**Advisory Action
Before the Filing of an Appeal Brief**

10/689,289

TITLE: FLAME GAS TURBINE ENGINE
WITH FIXED GEOMETRY INLET
INVENTOR: JAMES E. JOHNSON
DOCKET: 133476
ATTY: STEVEN J. ROSEN; PHONE: (513) 489-5353

FIG. 7

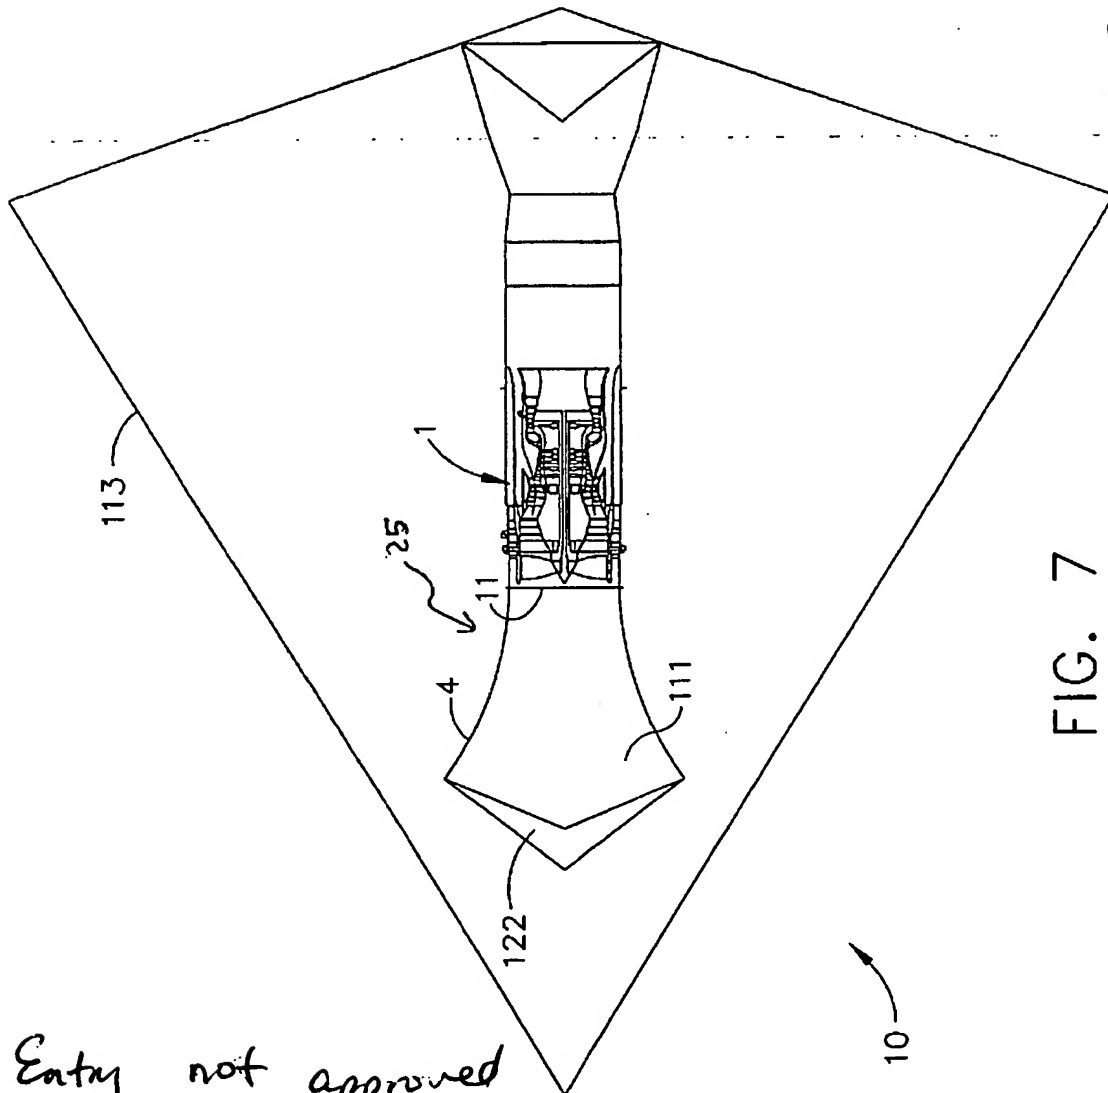
Continuation of 13. Other: the replacement drawing of 12/26/2005 has been considered and not entered. Element 113 is supposed to be the engine fuselage, rather it appears to be a wing. Hence, applicant's drawing would bring in new matter in that by definition a fuselage does not include the wing.

Entry not approved
